Supplemental Note:
Dewatering Assessment in Station Boxes and SCL Tunnels (Version 2)

TBC | P02

MetroLink

Project No: 32108600
Document Title: Supplemental Note: Dewatering Assessment in Station Boxes and SCL Tunnels (Version 2)
Document No.: TBC
Revision: P02
Date: 06/03/2024
Client Name: TII / NTA
Client No:
Project Manager: Paul Brown
Author: Jose A Aparicio
File Name: TBC

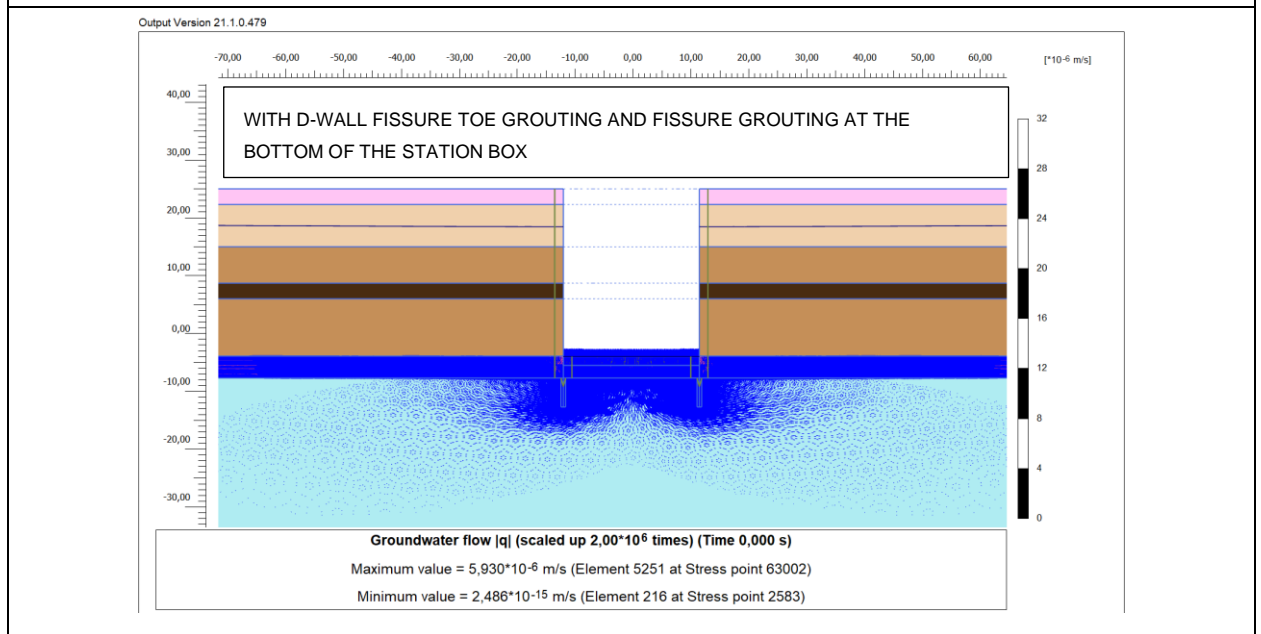
1.1 Can TII detail the dewatering strategy and the related settlement issues?

However, in order to reduce the water inflow through the bottom of the station, an additional third scenario has been shown applying fissure grouting at the bottom of the station box. This methodology would only be undertaken where it was necessary to reduce the volume of inflow. This model has been included as Appendix A to the present supplemental note. The scenarios are presented below.

- 2) With the application of the toe grouting methodology, the flow rates are $0.034 \times 10^{-3} \text{ m}^3/\text{s/m}$ ($2.93 \text{ m}^3/\text{d/m}$) and the modelling indicates no measurable lowering of the water table beyond the structure and consequently no settlement issues. Consequently, settlement does not occur. This application of the bottom grout alongside the toe grouting negates the need for any significant sump pumping within the open excavation.

- 3) Finally, applying the fissure grout at the bottom of the station box, together with toe fissure grouting at the D-Walls, the flow rates are further reduced to $0.018 \times 10^{-3} \text{ m}^3/\text{s/m}$ ($1.55 \text{ m}^3/\text{d/m}$) and again, the modelling indicates no lowering of the water table beyond the structure.

Water inflow through the bottom of Glasnevin station box without D-walls toe grouting

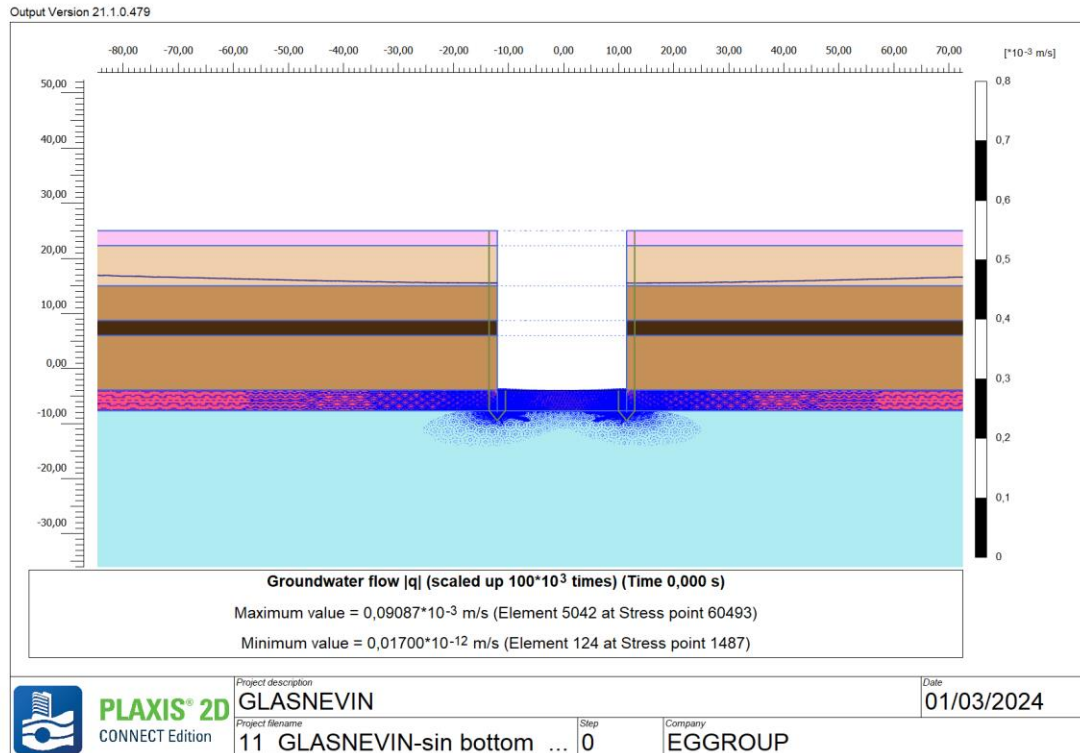
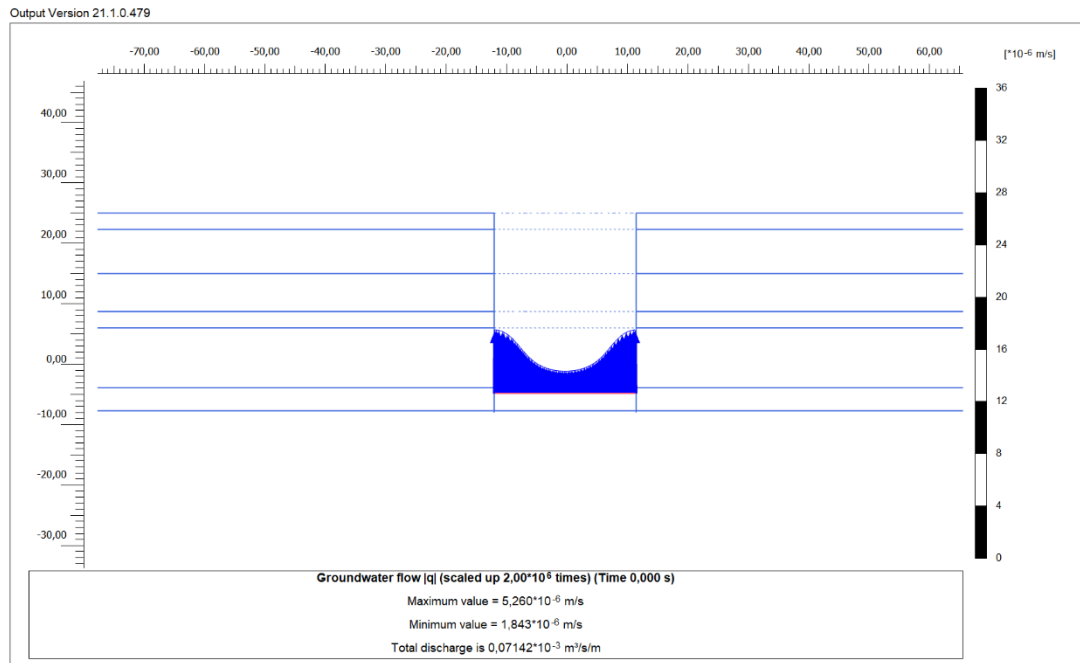
1.- STATION BOX INFLOW RATES WITHOUT D-WALLS TOE FISSURE GROUTING INTO THE ROCK MASS.

Flow rates = $0,071 \times 10^{-3} \text{ m}^3/\text{s}/\text{m}$ (6.13 $\text{m}^3/\text{d}/\text{m}$ or 6.81 l/s along the whole station)

Lowering of the groundwater level. Decrease of approximately four (4) meters.

Flow rates to the bottom of Glasnevin station box

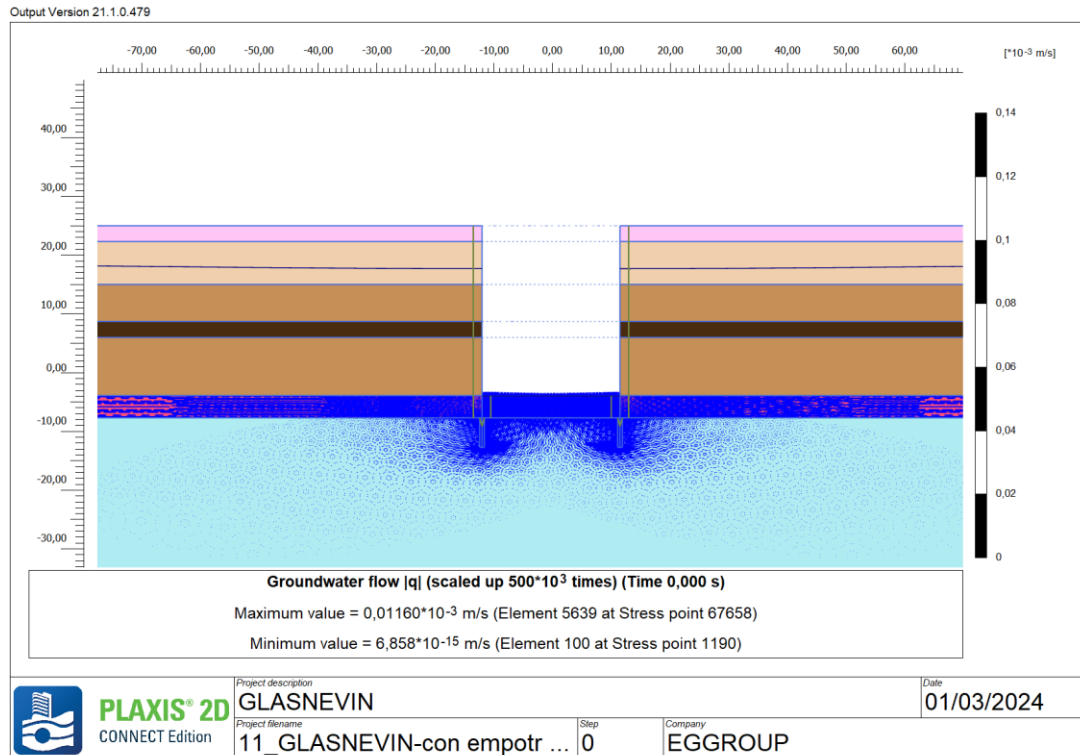
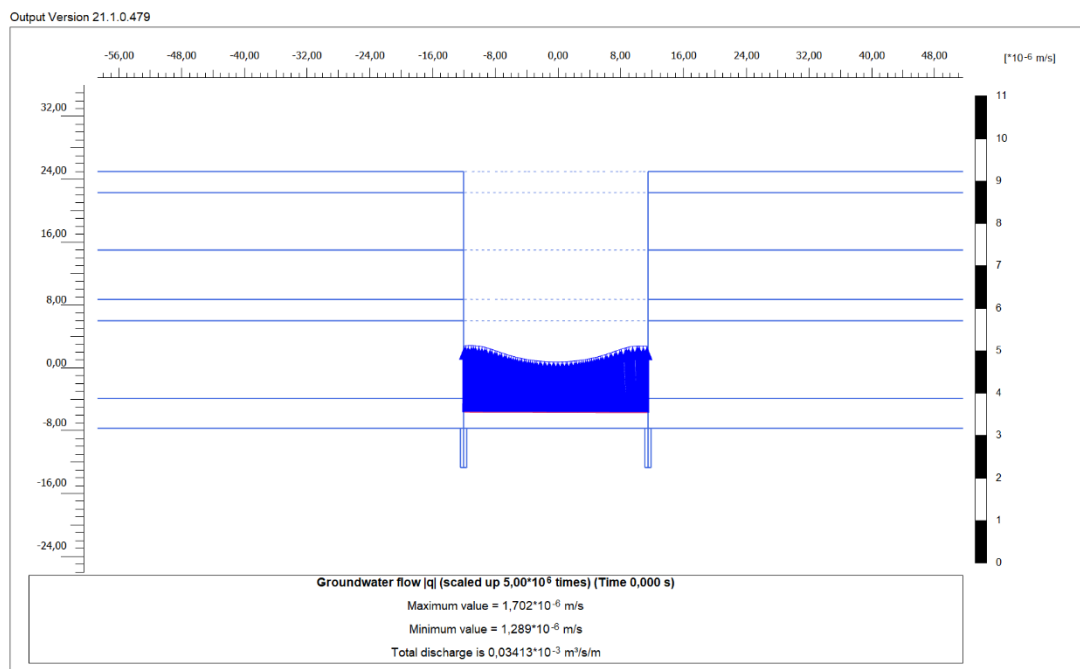
2.- STATION BOX INFLOW RATES CONSIDERING D-WALLS TOE FISSURE GROUTING 5M INTO THE ROCK MASS.

Flow rates = $0,034 \times 10^{-3} \text{ m}^3/\text{s}/\text{m}$ ($2.9 \text{ m}^3/\text{d}/\text{m}$ or $3,2 \text{ l/s}$ along the whole station)

Groundwater level remains unchanged.

Flow rates to the bottom of Glasnevin station box

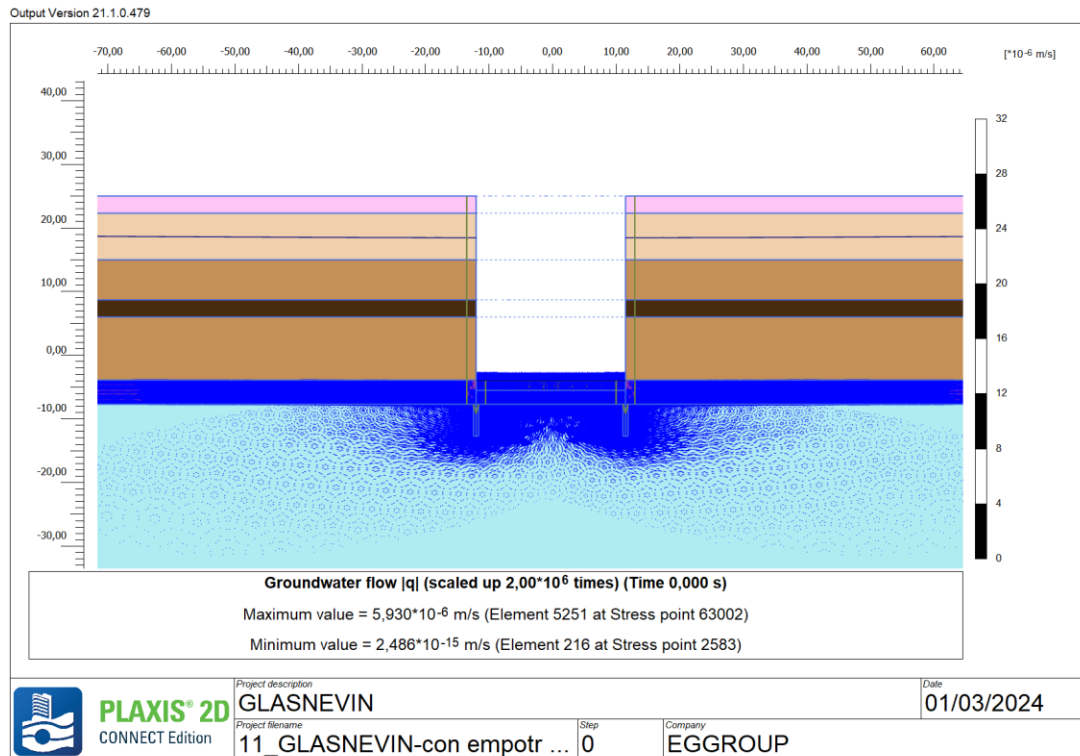
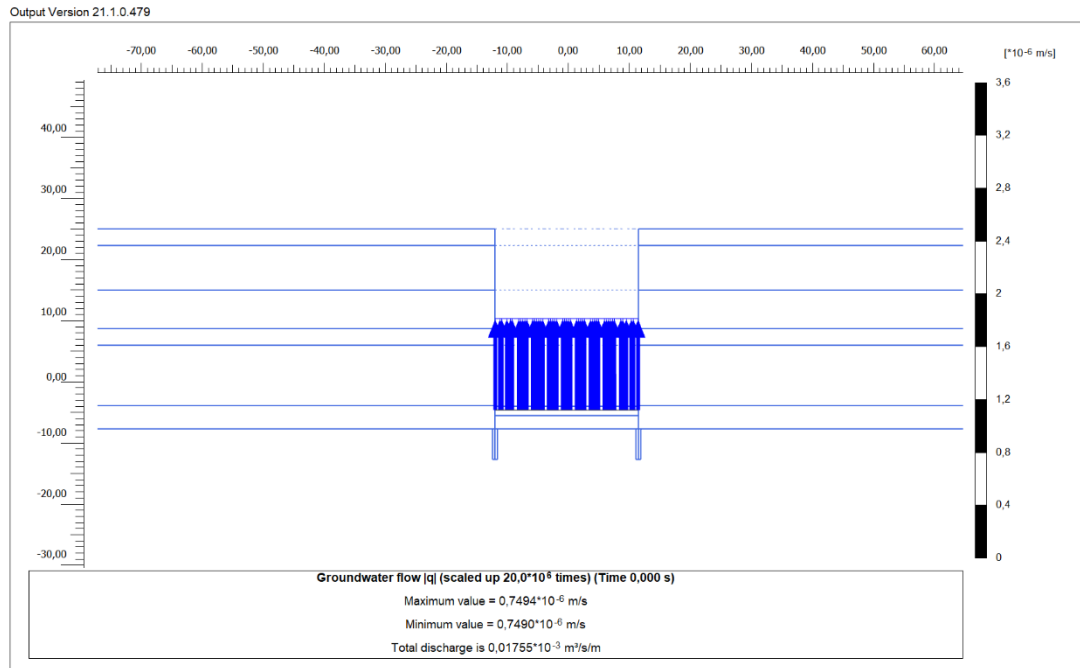
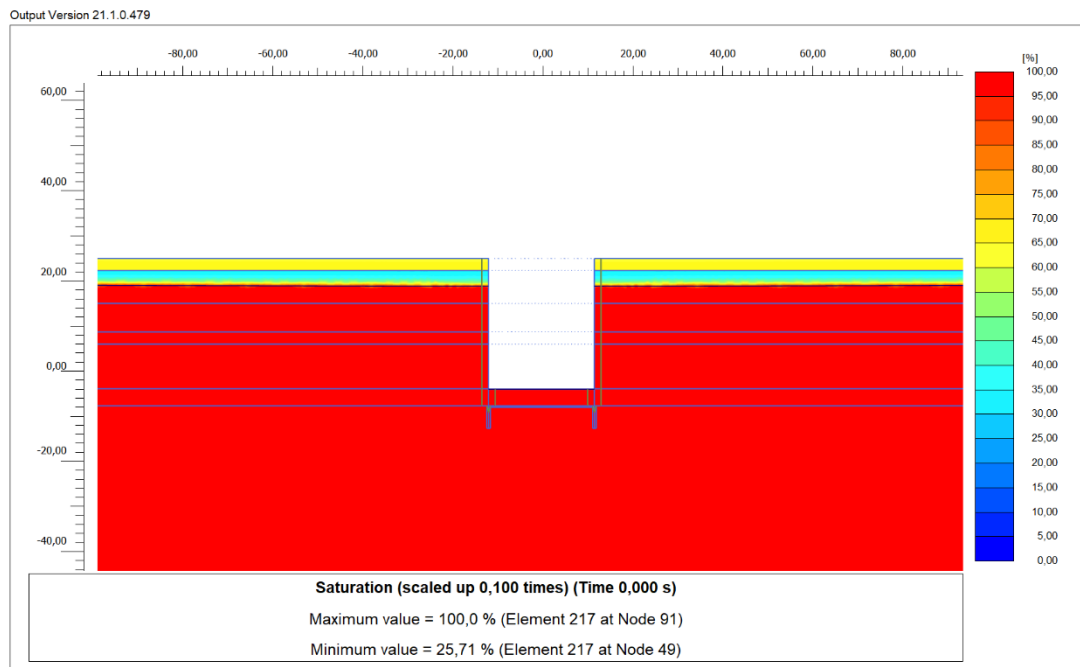
3.- STATION BOX INFLOW RATES CONSIDERING D-WALLS TOE FISSURE GROUTING 5M INTO THE ROCK MASS AND FISSURE GROUTING AT THE BOTTOM OF THE STATION BOX.

Flow rates = $0,018 \times 10^{-3} \text{ m}^3/\text{s}/\text{m}$ ($1.5 \text{ m}^3/\text{d}/\text{m}$ or 1.7 l/s along the whole station)

Groundwater level remains unchanged.

Groundwater level remains unchanged.

1.- EXCAVATION WITHOUT GROUTING AT THE TUNNEL FACE

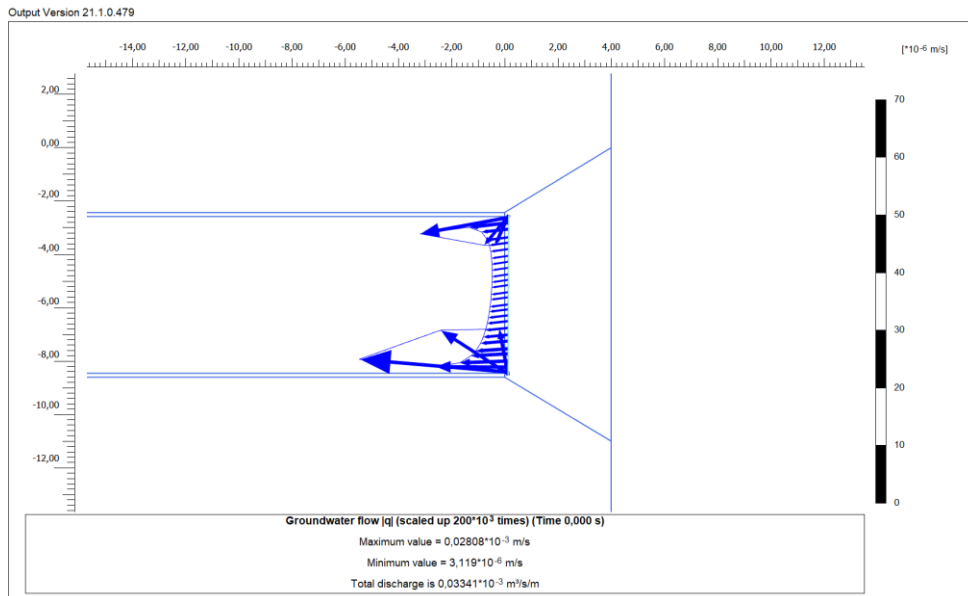
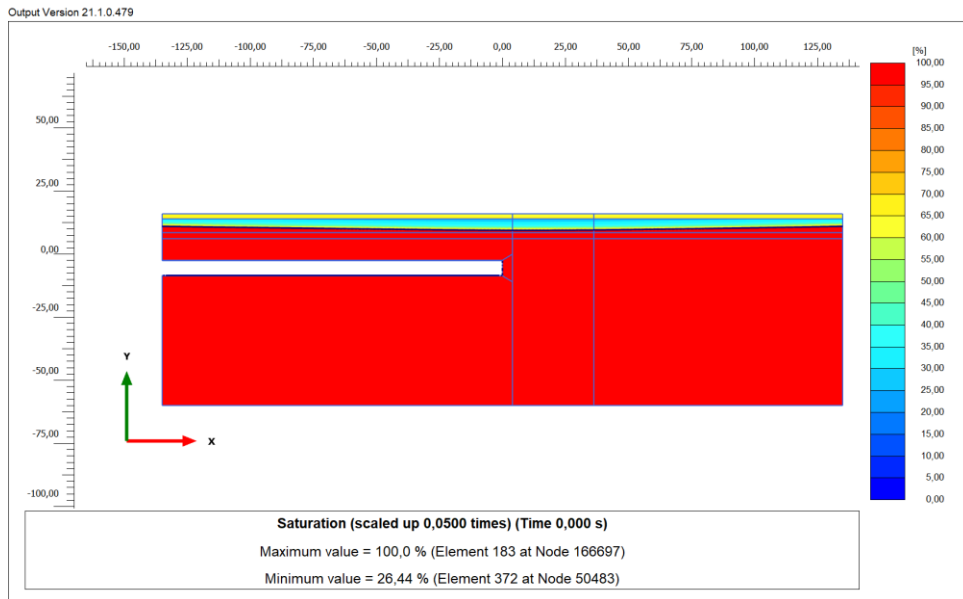
Flow rates of 33 l/s/m (\approx Section $A=33\text{m}^2$). $Q_{\text{total}} = 33 \times 5.5 = 181\text{l/s}$

In this case lowering of the groundwater level. Decrease of 1.6m.

2.- FISSURE GROUTING 6m LENGTH. TUNNEL EXCAVATION SECTION AND AT THE SECTION FACE

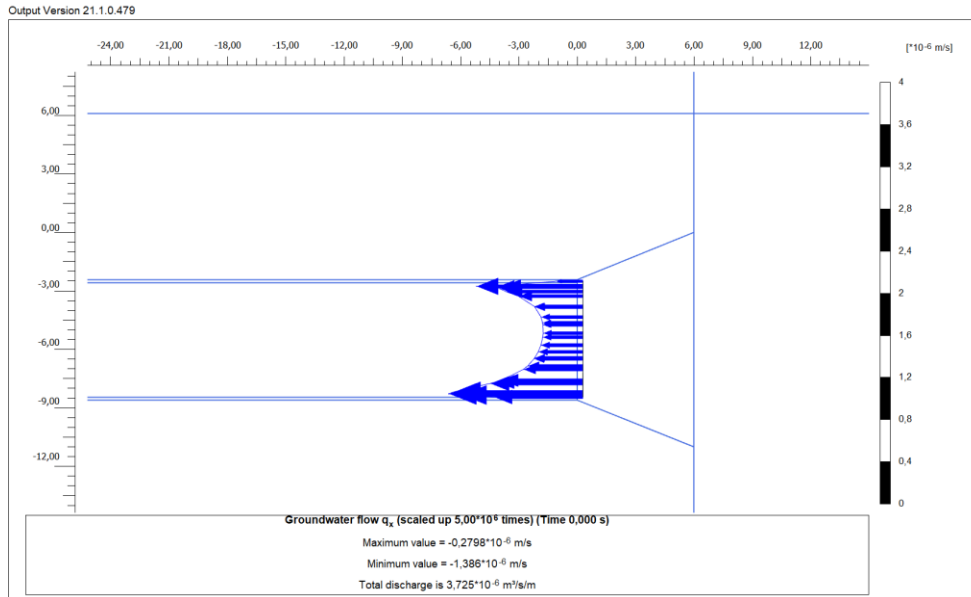
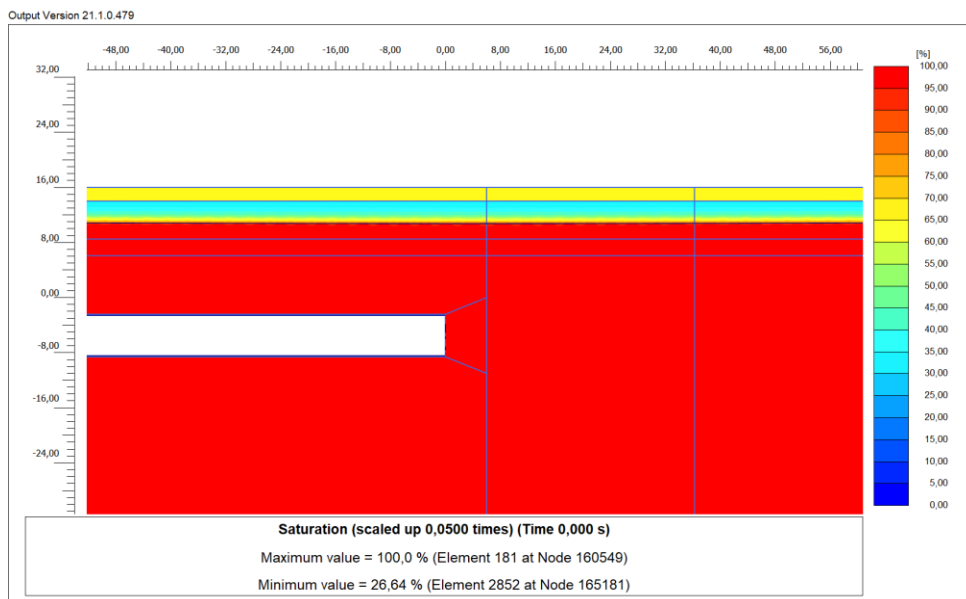
Fissure Grouting with permeability of $K=10^{-7}$ m/s.

Flow rates of 3.7×10^{-3} l/s/m (\approx Section $A=33\text{m}^2$). $Q_{\text{total}} = 3.7 \times 10^{-3} \times 5.5 = 20.3 \times 10^{-3}$ l/s (0.02 l/s)

Lowering of the groundwater level of 0.23m.

Fissure Grouting with permeability of $K=10^{-8}$ m/s.

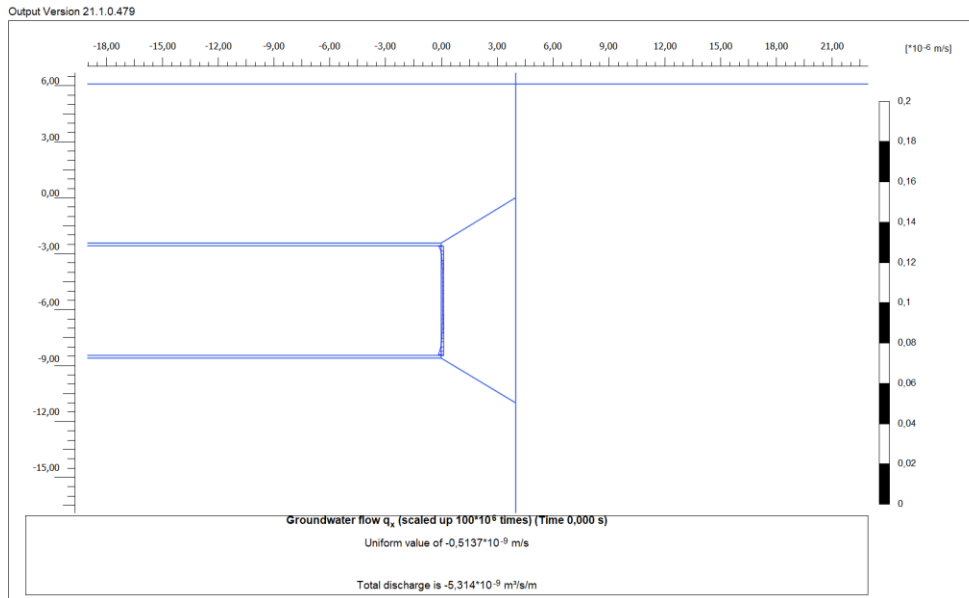
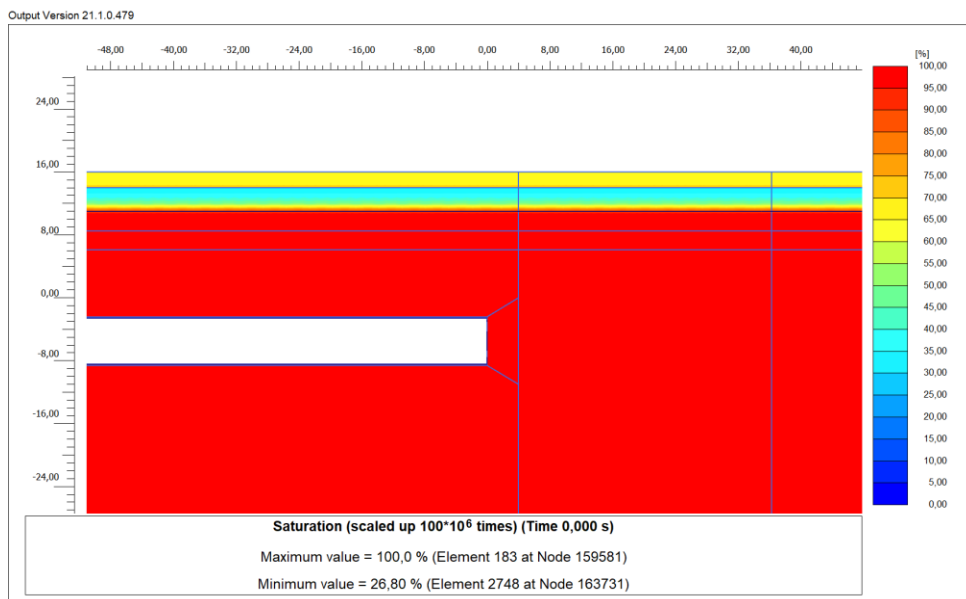
Flow rates of 5.3×10^{-6} l/s/m (\approx Section A=33m²). $Q_{\text{total}} = 5,3 \times 10^{-6} \times 5.5 = 30 \times 10^{-6}$ l/s

Groundwater level remains unchanged.
